AIR CONDITIONER

■ DESCRIPTION

Ceiling Grill (No. 3 Air Duct Register Assembly)
: Models for India

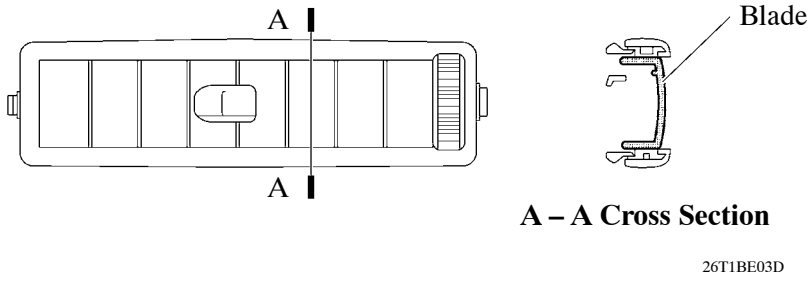
- A ceiling grill (No. 3 air duct register assembly) with a newly designed bezel shape has been adopted for the India package models. No grill is changed for the models other than the India package models.

Square Grill (No. 3 Air Duct Register Assembly)
: Models for India

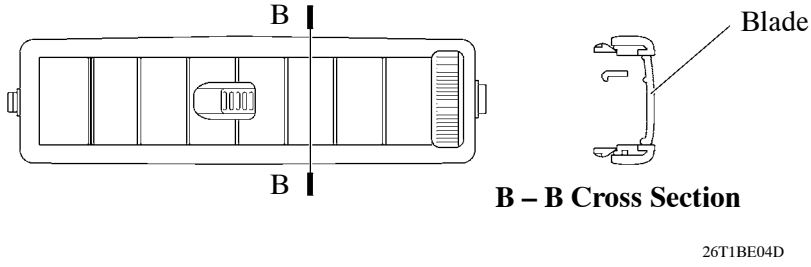
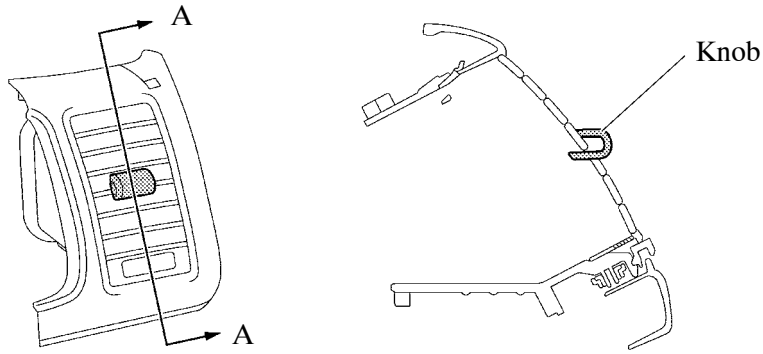
- For the India package models, a new square grill (No. 3 air duct register assembly), in which the position of the blade has been moved to the back of the grill, has been provided. No position is changed for the models other than the India package models.

No. 1 Instrument Panel Register Assembly
: Models for India

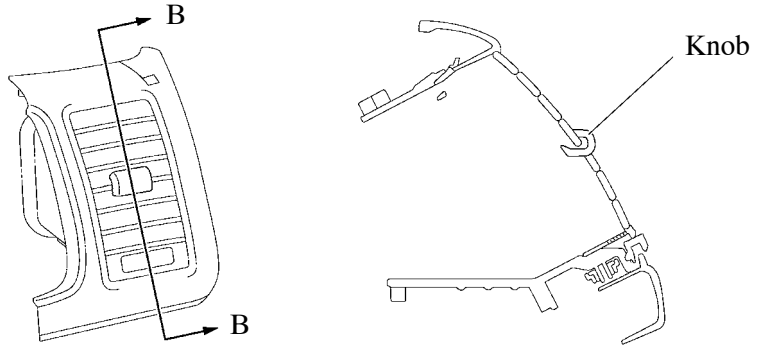
- A No. 1 instrument panel register assembly with a newly designed knob shape has been adopted for the India package models. No position is changed for the models other than the India package models.
